### **Agenda Item 3**

### **Deerpath Park**

**THE CITY OF LAKE FOREST  
BUILDING REVIEW BOARD APPLICATION**

**Consideration of a request for modifications to the amenity buildings (north and south pavilions) proposed to support the athletic fields.**

SOUTH PAVILION - MODIFIED

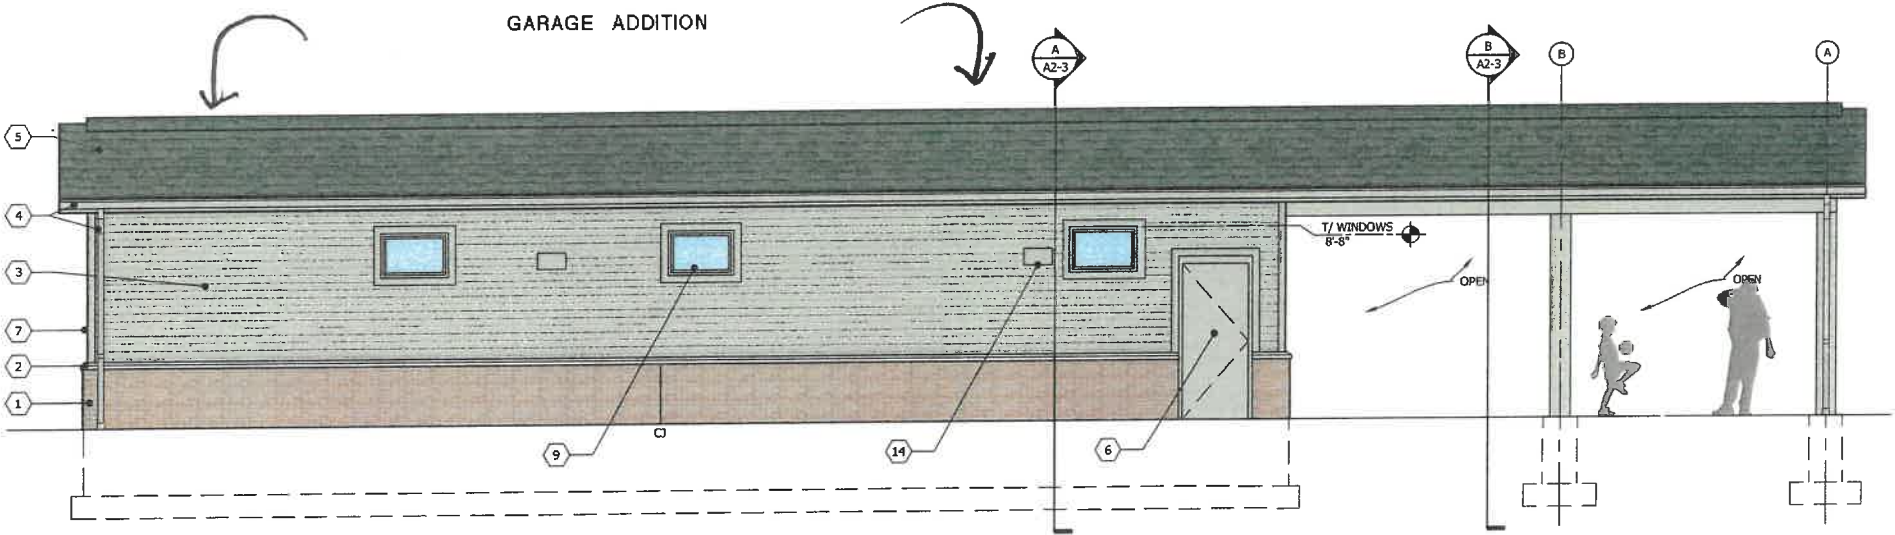
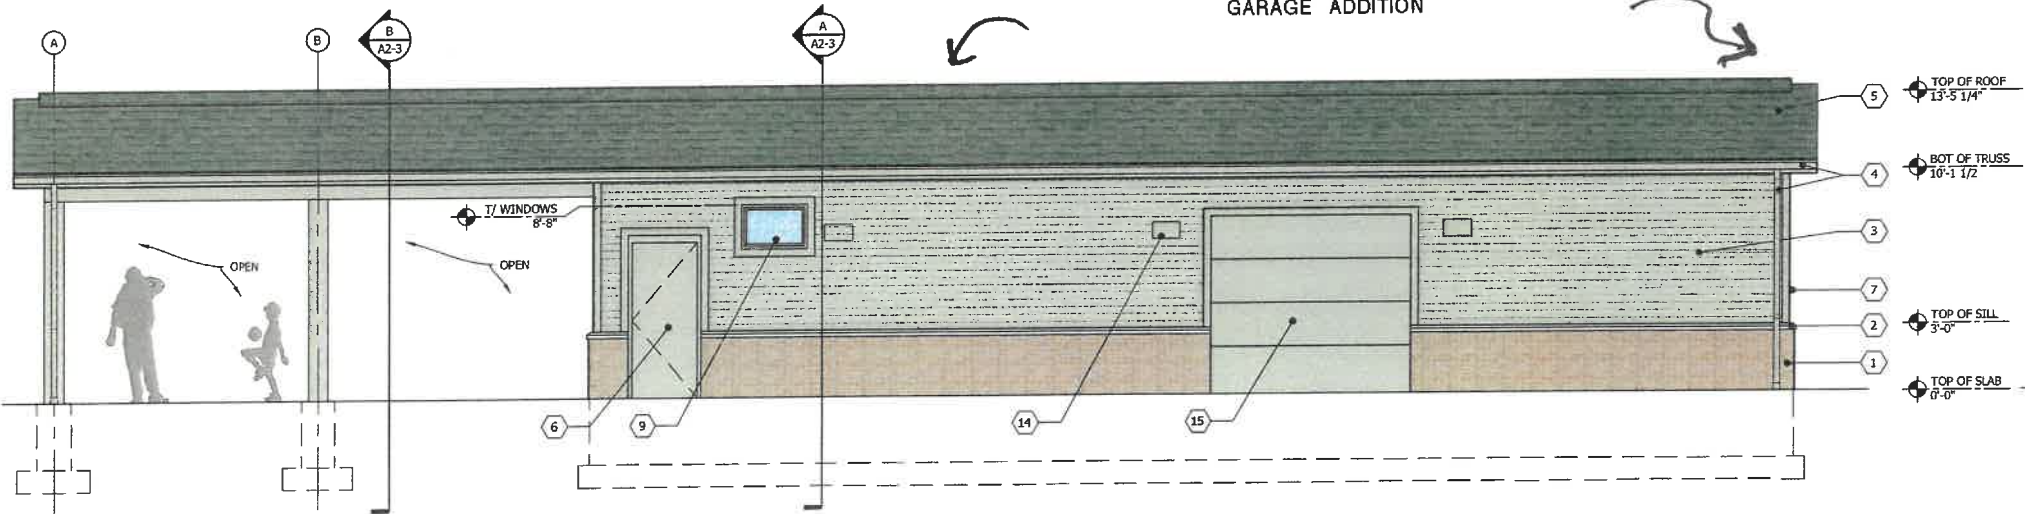
1. Size the columns in the pavilion to appear visually appropriate and proportional in relation to the roof structure. (The column thickness appears thin on the drawings.)
2. Set the base of the columns on an appropriate concrete plinth to provide protection from moisture.
3. Provide brick knee walls around the enclosed portion of the structure.
4. Expose the structure in the open portion of the pavilion.
5. Assure consistency between the design aspects and materials of the north and south pavilions.

**A-4 4 19**  
**PROPOSED  
SITE PLAN**

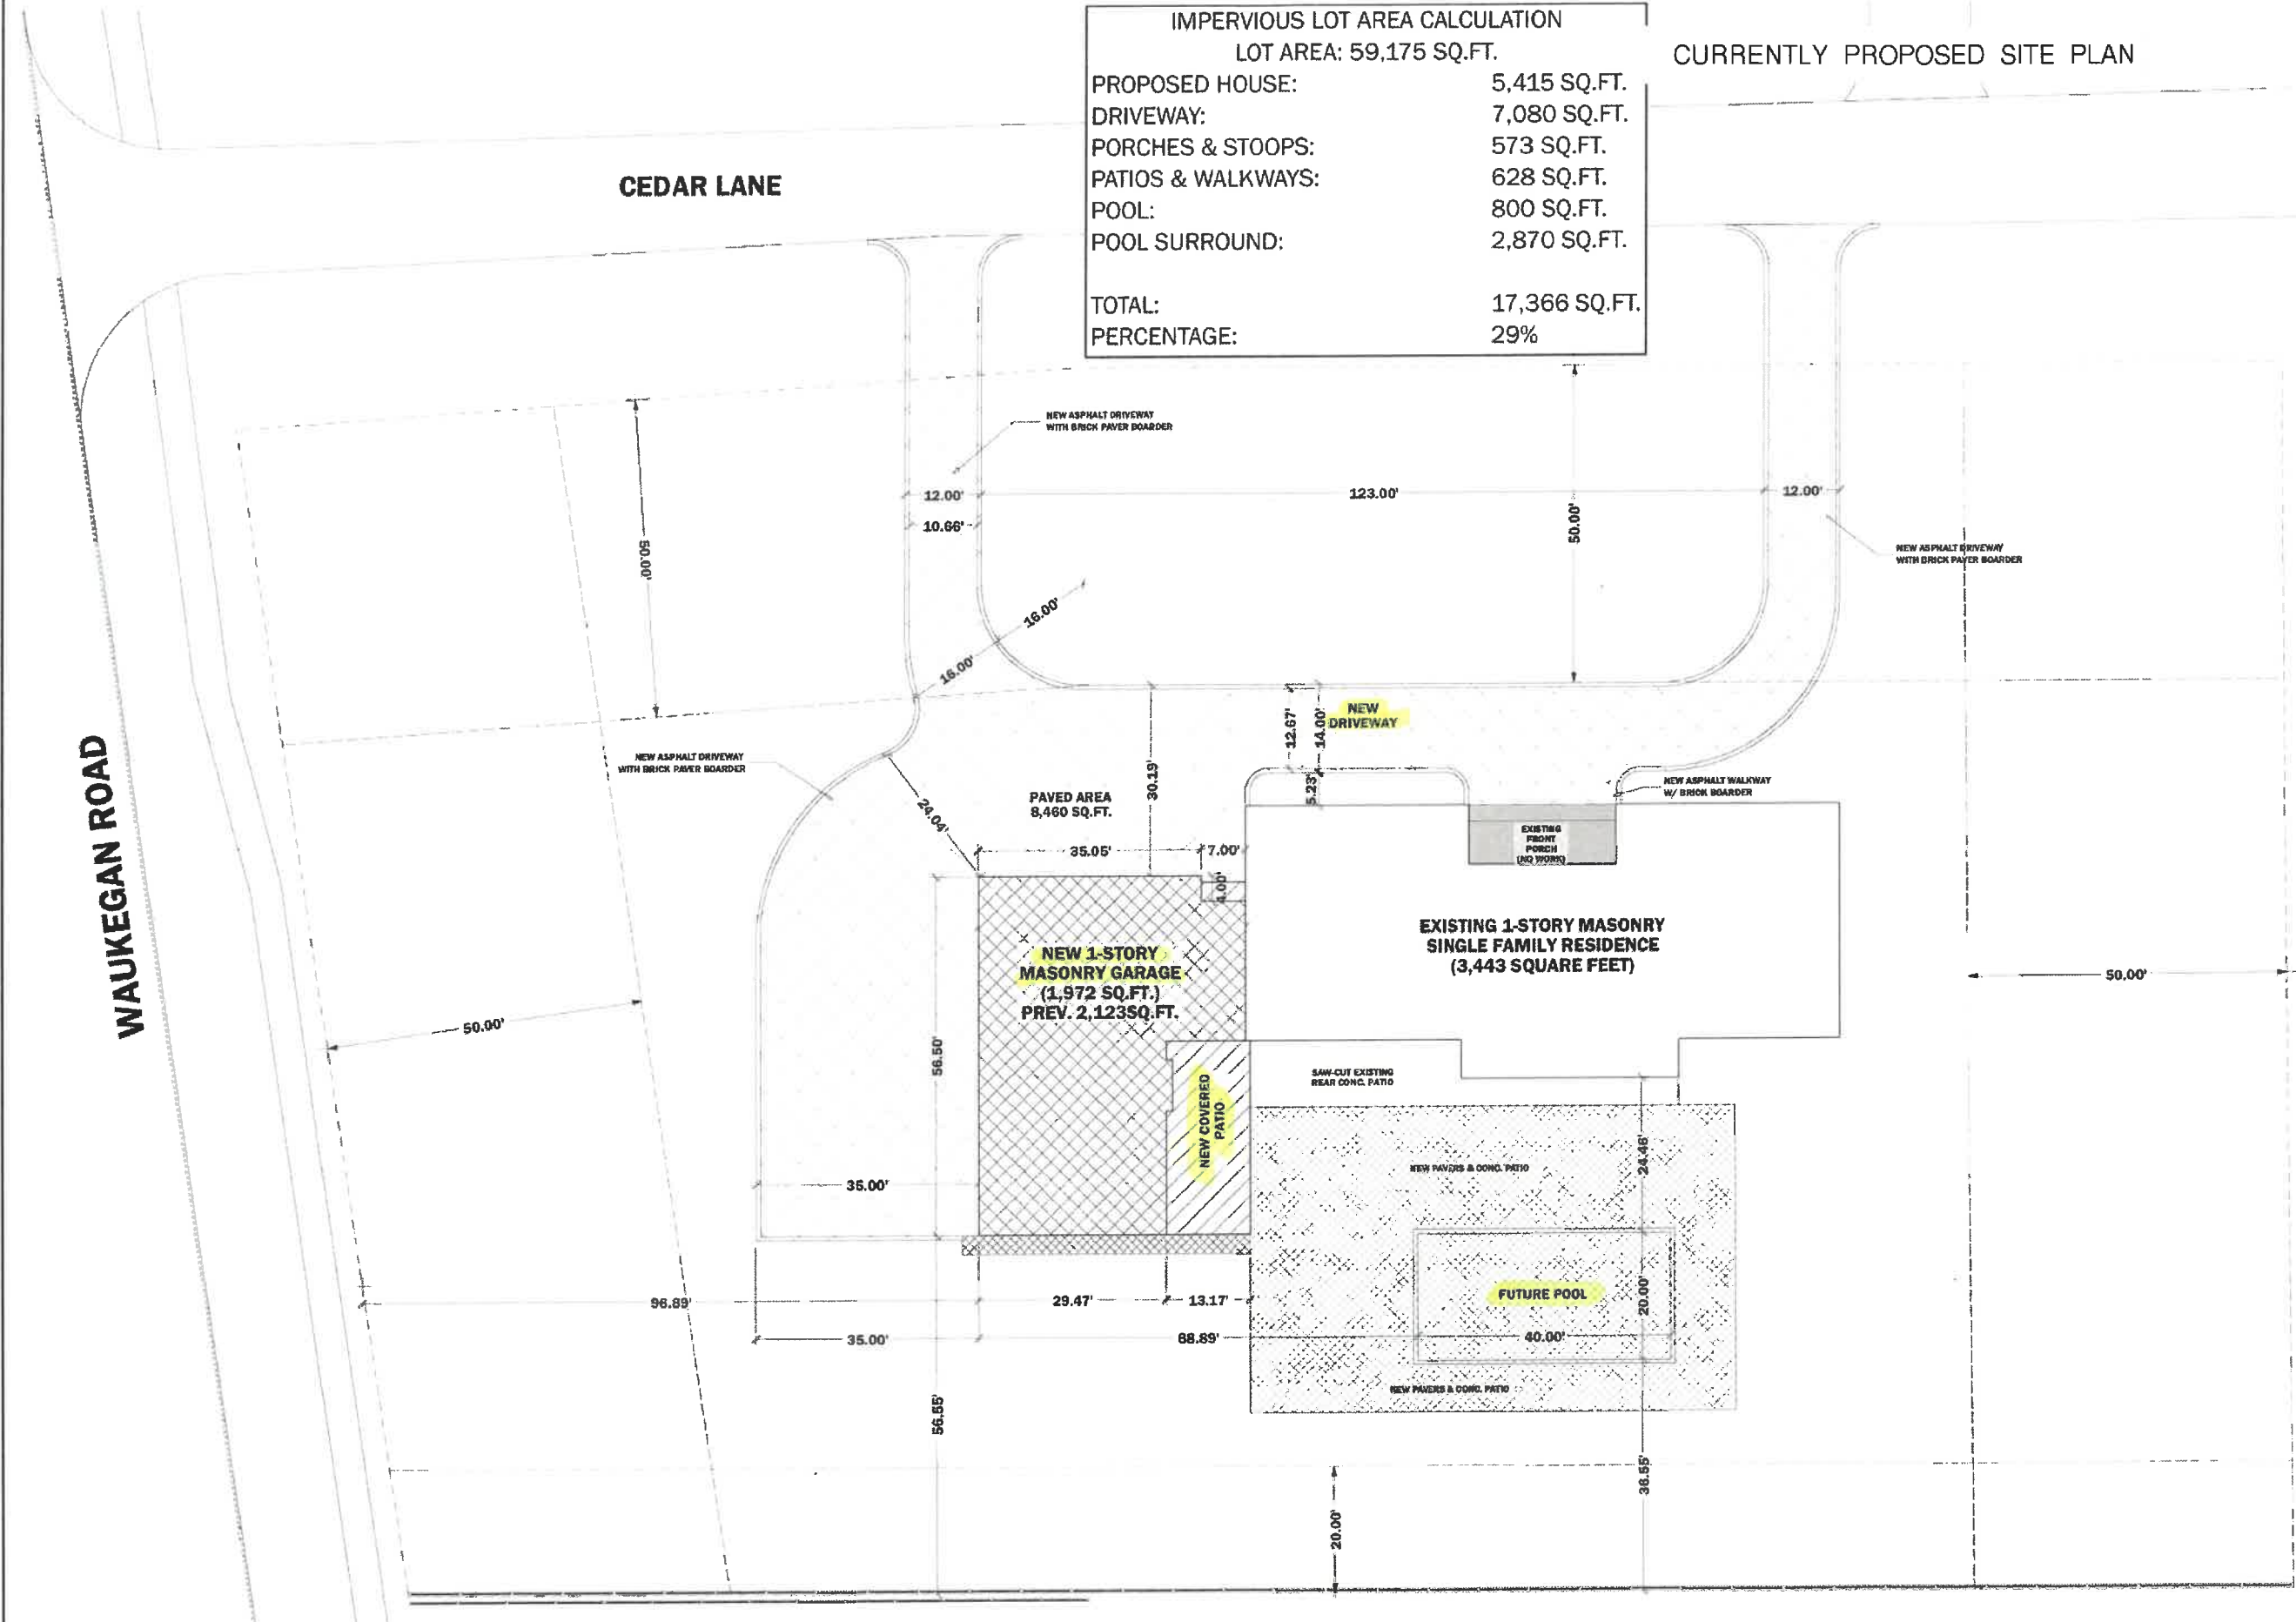
- Revise the driveway configuration to meet the zoning regulations.
- Provide an updated site plan that reflects the location of the potential future pool to allow the Board to be aware of the potential full scope of work.

- The petitioner studied different driveway configurations in an effort to meet the zoning regulations. To date, a plan that fully meets the zoning regulations has not been submitted and the driveway configuration shown on the proposed site plan in the Board's packet is not fully in compliance with the Code. Prior to the issuance of permits, a plan in full conformance with the applicable zoning requirements must be submitted.

**Two Driveway reconfiguration options provided in order to comply with zoning regulations. I would like to clarify that my interpretation of the requirement is that the perpendicular width of the driveway itself is not to exceed 16' within the front yard setback; for which all options comply. The Review Board appears to be dimensioning in a manner parallel to the setback line, and not perpendicular to the width of the driveway which seems to cause a conflict of interpretation.**

**Site plan revised to show location and preliminary sizing of potential future pool. The homeowner would like to clarify that the plan for the pool is more of a "future goal" and is not a committed project at this time. The proposal is completely depending on funds available for the work; for which currently any engagement of the pool design and construction would be delayed as a future phased project. Pool and hardscape surround have been provided for reference only.**

**NORTH &  
WEST  
ELEVATIONS**

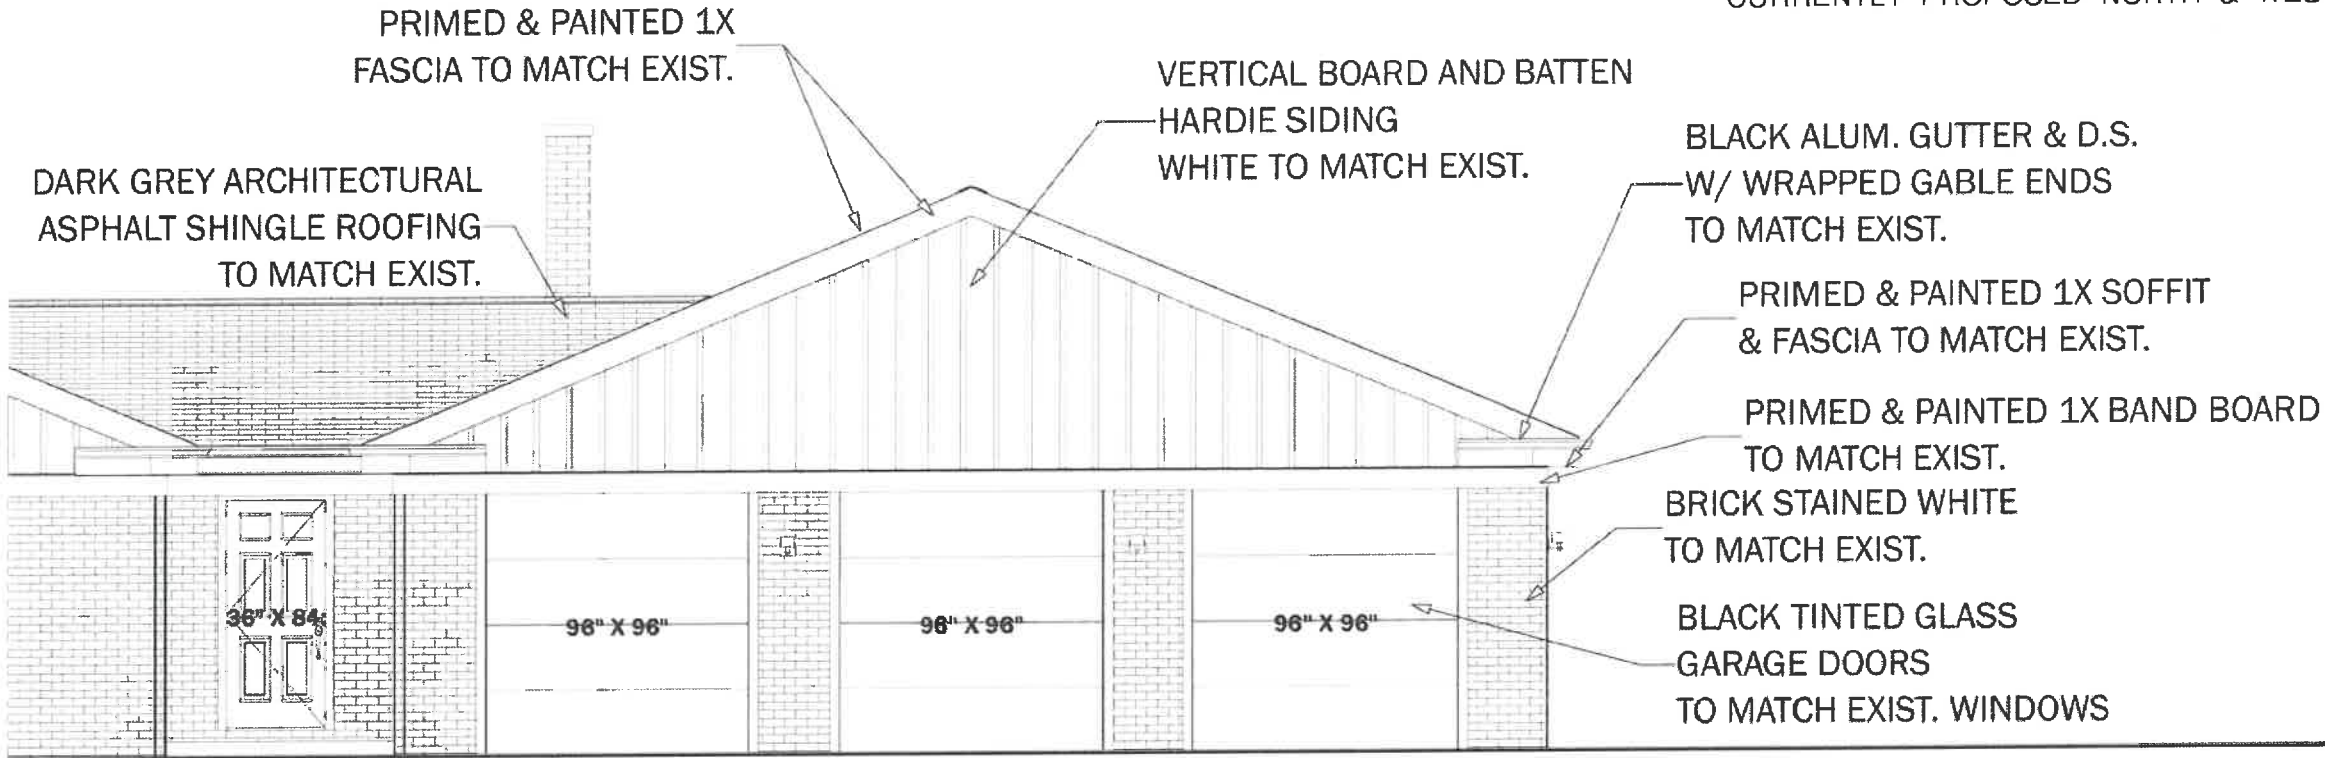
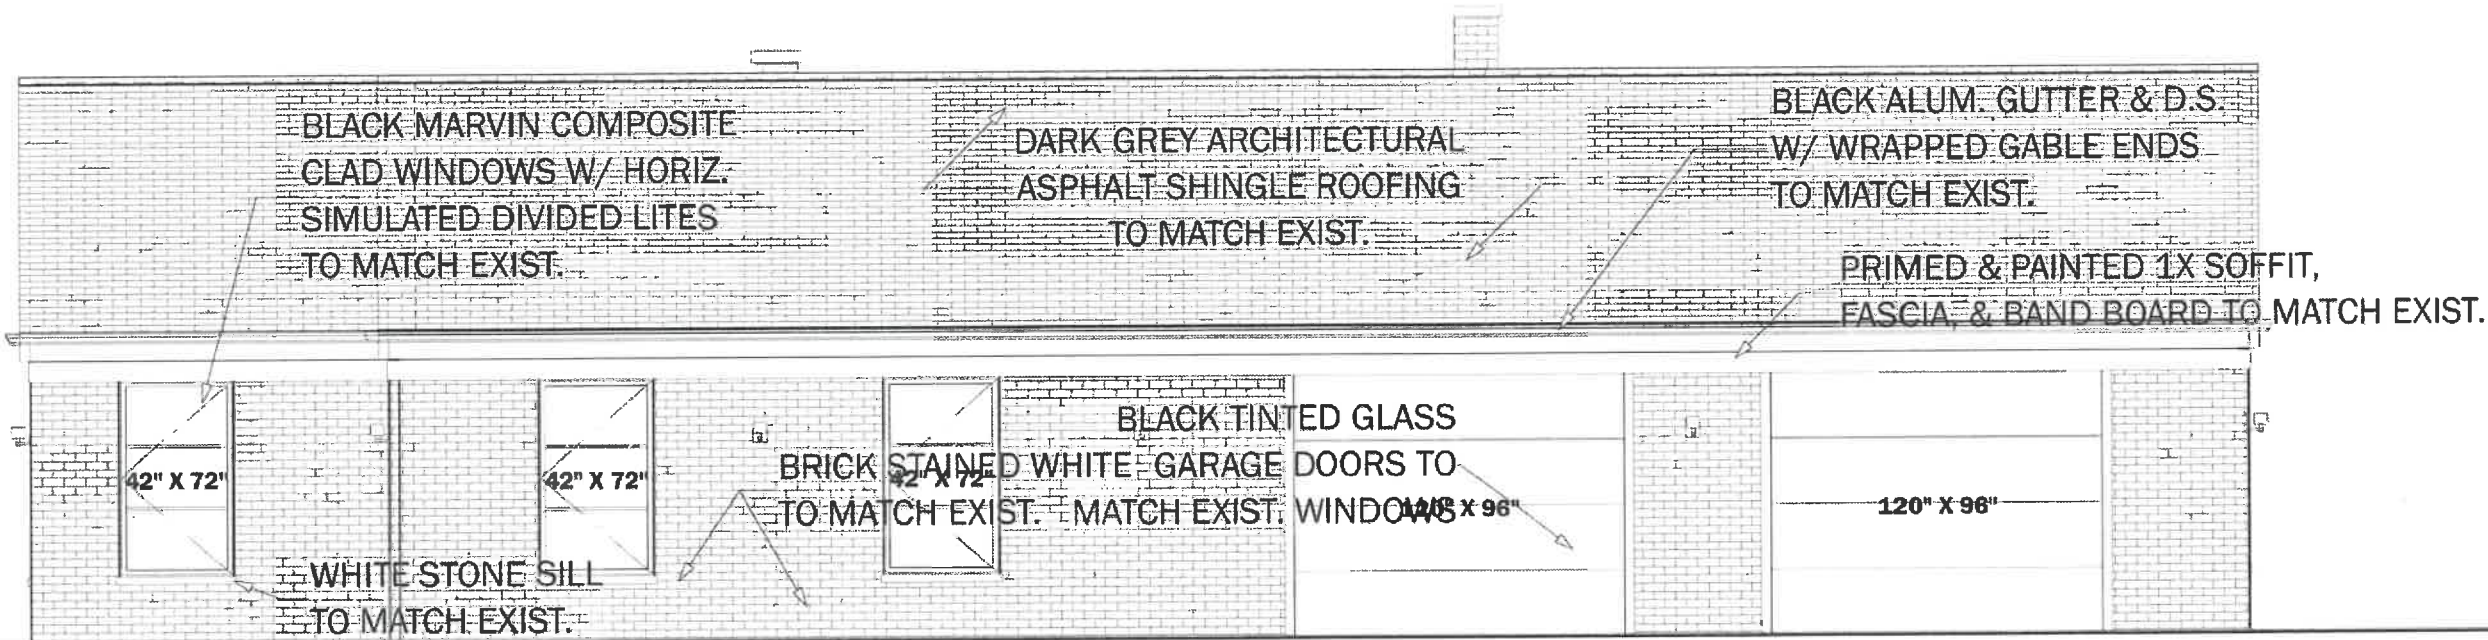
- Incorporate openings on the west elevation to break up the solid wall.
- Incorporate a clay chimney pot or decorative cap on the new chimney.
- Accurately reflect the height of the garage doors on the elevations.
- Explore garage doors that are residential in appearance and provide images of the proposed garage doors.
- Consider a covered entry element above the rear kitchen door.
- Consider design elements to mitigate views of the outdoor television from the neighboring homes.

- The petitioner incorporated windows on the west elevation to break up the solid wall.
- The height and width dimensions of the garage doors are now reflected on the plans.

**Additional windows added to break up the solid wall. Windows will be of the same size, scale, and finish as those within the existing residence in order to assist in providing a more residential appearance.**
